Access Compliance Report

Public Rights-of-Way

Intersection ID: 14341	Main Street: BAY_ST	Cross Street: LORNA_ST	Location:	W
ADA ID: 8F2F55D3C5F7	Ramp Type: Perpendicular Diagonal	Initial Pass/Fail: Fail	Overall Compliance: No	Severity Score: 25

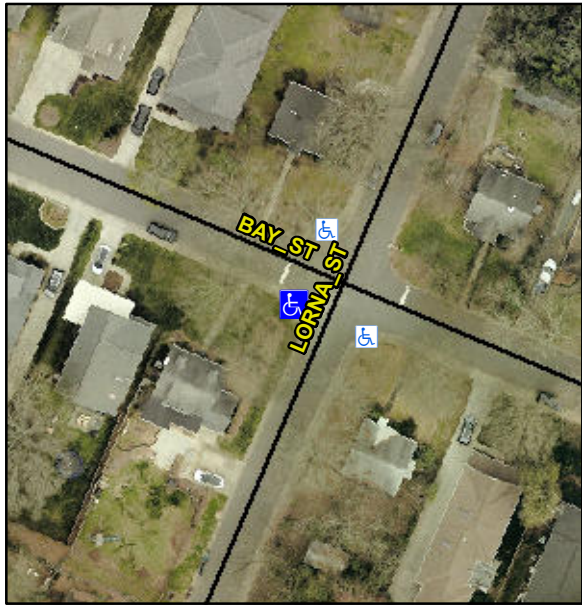
Codes/Mitigation Info/Possible Solution			Field Measurements/Component Compliance					
	Possible Solutions:		Compliance	Description	Data	Compliance	Description	Data
	Remove & Replace Curb Ramp With Two New Directional Ramps or Equivalent.		N/A	Ramp Length (in)	60.0	Yes	Ramp Slope (%)	7.5
			Yes	Ramp Width (in)	106.0	No	Ramp XSlope (%)	8.2
			N/A	Flare Type LT	N/A	N/A	Flare Type RT	N/A
			N/A	Flare Slope LT (%)	N/A	N/A	Flare Slope RT (%)	N/A
			N/A	Flare Traversable LT?	N/A	N/A	Flare Traversable RT?	N/A
			N/A	Landing Length (in)	N/A	N/A	DWS Provided?	N/A
			N/A	Landing Width (in)	N/A	N/A	DWS Contrast?	N/A
			N/A	Landing Slope (%)	N/A	N/A	DWS Length (in)	N/A
			N/A	Landing X Slope (%)	N/A	N/A	DWS Full Width?	N/A
Surveyor Notes:		N/A	N/A	Landing Curb? (Y/N)	N/A	N/A	DWS Offset (in)	N/A
PROW/ADA:		Not Found, R304.5.3	N/A	Shared Landing?	N/A			
			N/A	Gutter Ponding?	N/A	N/A	Gutter Slope (%)	N/A
			N/A	Gutter Lip Ht (in)	0.5	N/A	Gutter X Slope (%)	N/A

N/A	Painted X Walk1?	No	N/A	Painted X Walk2?	No
				X Walk 1 Direction	To SE		X Walk 2 Direction	To NE
			N/A	X Walk 1 Width (in)	N/A	N/A	X Walk 2 Width (in)	N/A
				X Walk 1 Slope (%)	2.3		X Walk 2 Slope (%)	0.7
				X Walk 1 X Slope (%)	1.1		X Walk 2 X Slope (%)	3.3
			N/A	Ramp inside XWalk1?	N/A	N/A	Ramp inside XWalk2?	N/A
				Road Slope (%)	3.3	N/A	Clear Space?	N/A
				Road X Slope (%)	1.3	N/A	Clear Space to XWalk (in)	N/A
			N/A	Any Obstructions?	N/A	N/A	Storm Grate/Utility Hazard?	N/A
				Obstruction Type			Storm Grate/Utility Type	
					N/A			N/A
						Yes	Surface Condition? (G/P)	Good
Street 1 Name		LORNA ST						
Stop Condition-Street 2		None						
Street 2 Name		BAY ST						
Stop Condition-Street 1		StopSign						
Total Cost:		\$ 3200.00
